CHANGE ORDER

PROJECT:
Construction of A Myers Road

CHANGE ORDER NUMBER 01

**A Myers Road from Exist A Myers Road to FM 762
FBC Mobility Project No.13102**

A. MYERS ROAD
L INEAR DETENTION
CHANNEL LAYOUT
STA 20+00.00 TO END

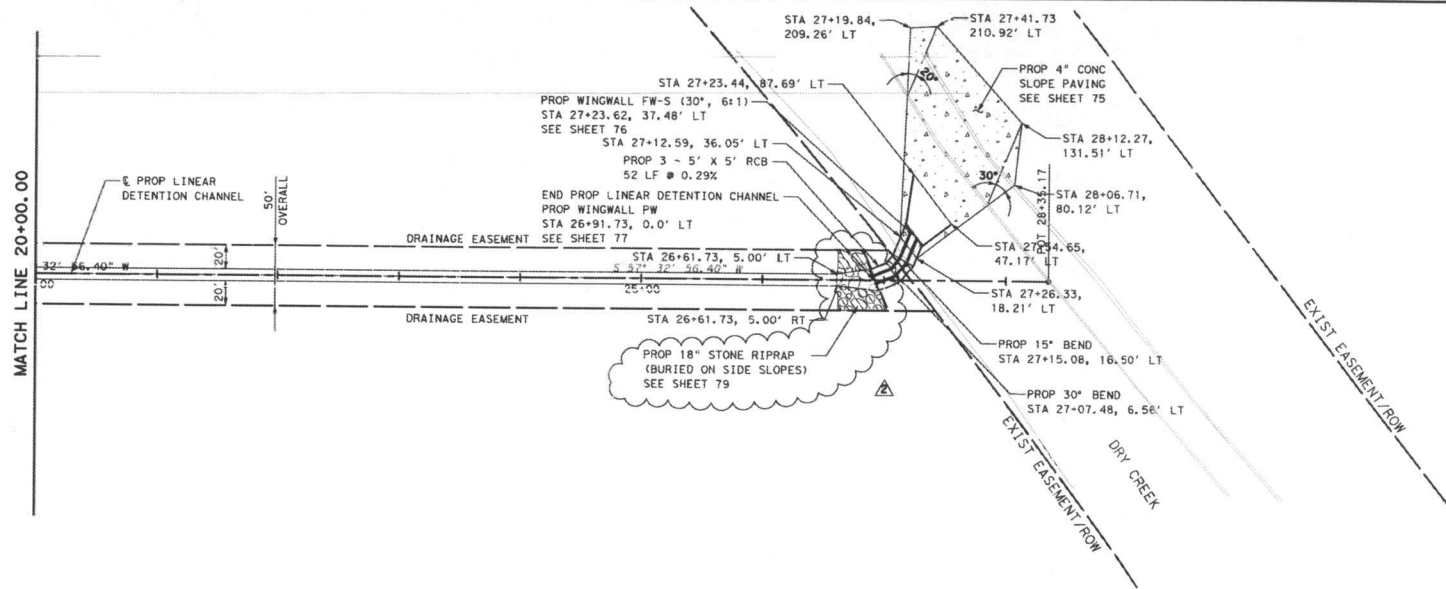
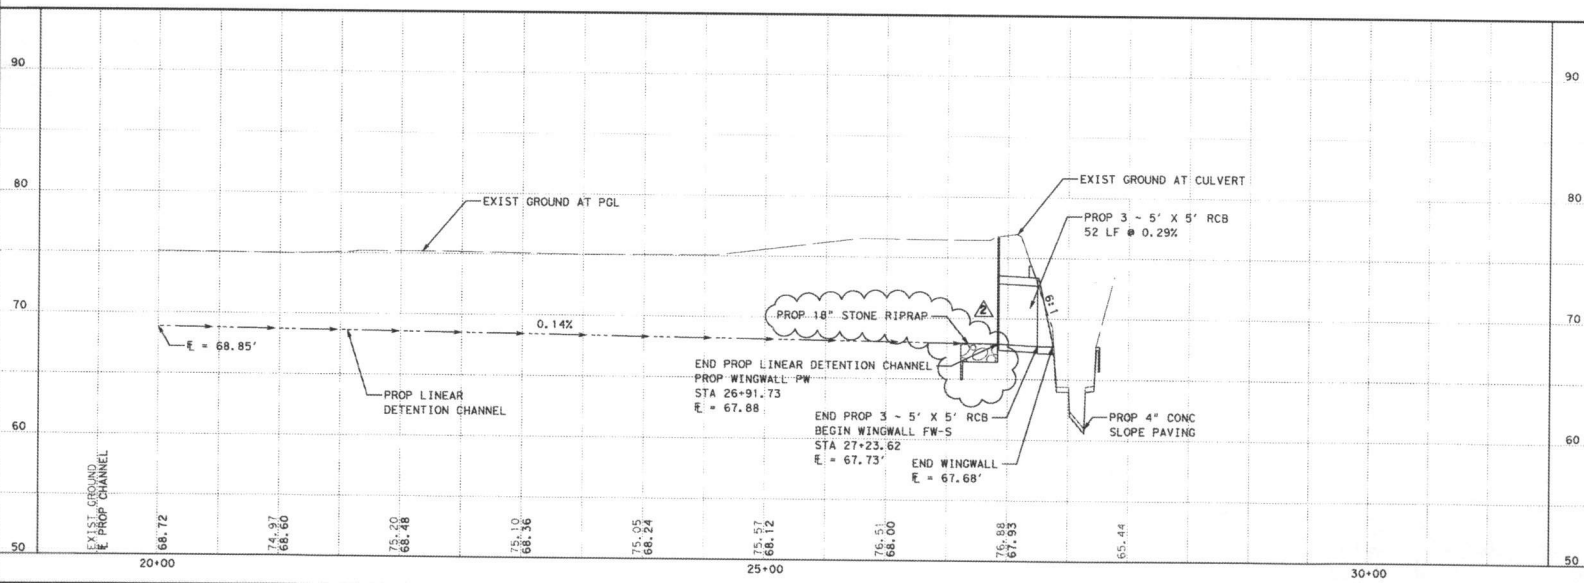
The contract is changed as follows:
Several items have been revised or added to the project such as Dry Creek Outfall Treatment (RFP #1 - 20 days), Lime Quantity/Thickness Issues (Ext #3 - 18 days), Additional 24" RCP (RFI #13 - 2 days) and RCB Review Issue (Ext #2 - 3 days). See attachments for details

RFP #1

A. MYERS ROAD
PLAN & PROFILE
 STA 80+00.00 TO END

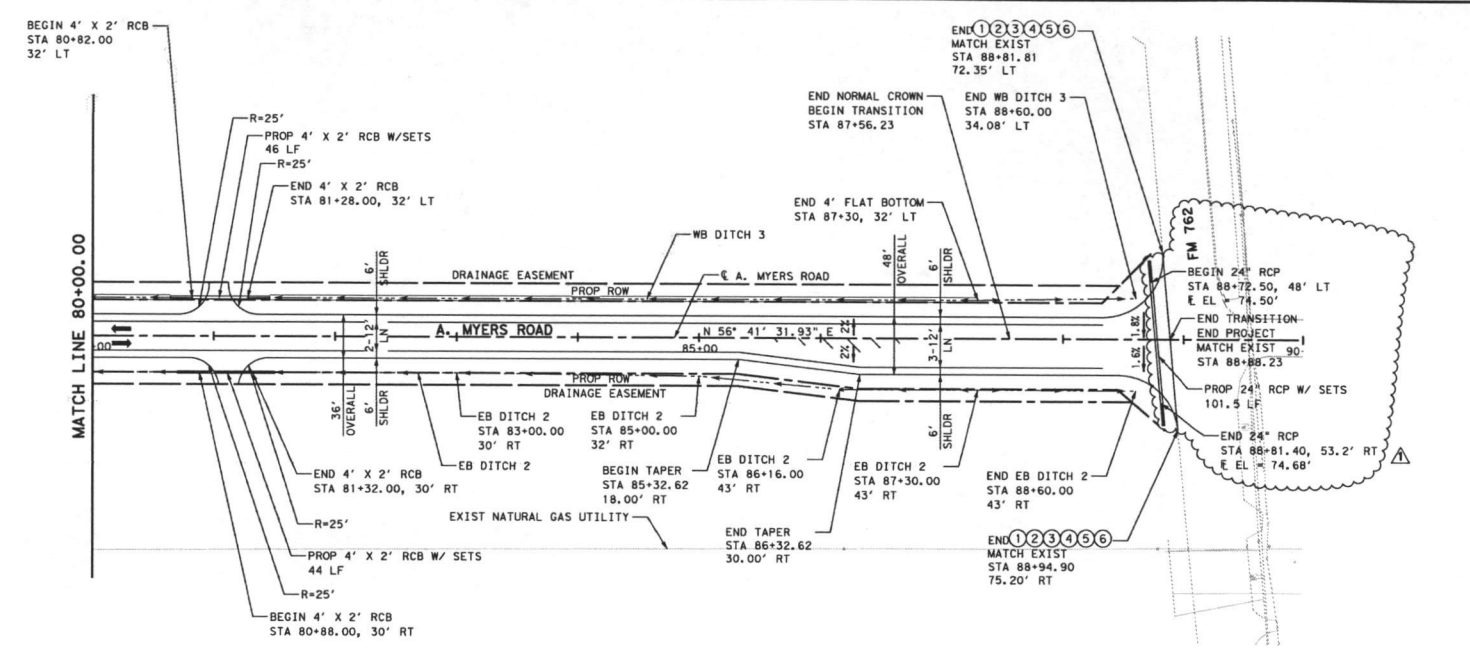
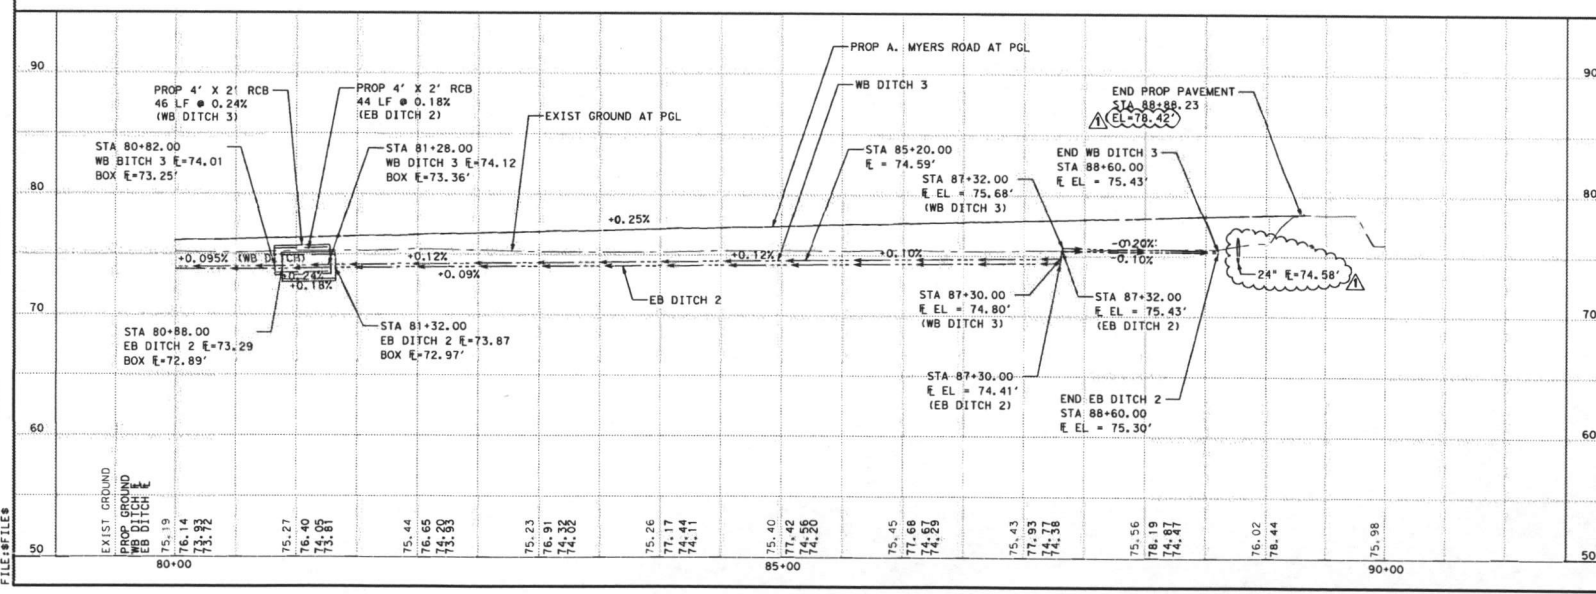
Required: Hurtado Construction submitted RFI No. 0012.00 in which 102 LF of 24-Inch RCP and 2 SET's were added to the project
In that same pipe run, Fort Bend usually required an inlet for anything over 50 feet. Will Hurtado Construction be required to add an
inlet, and if so, how will Hurtado Construction Company be compensated?

RFI #13

These drawings were submitted to TxDOT and they did not require an inlet. Proceed with the design
as drawn
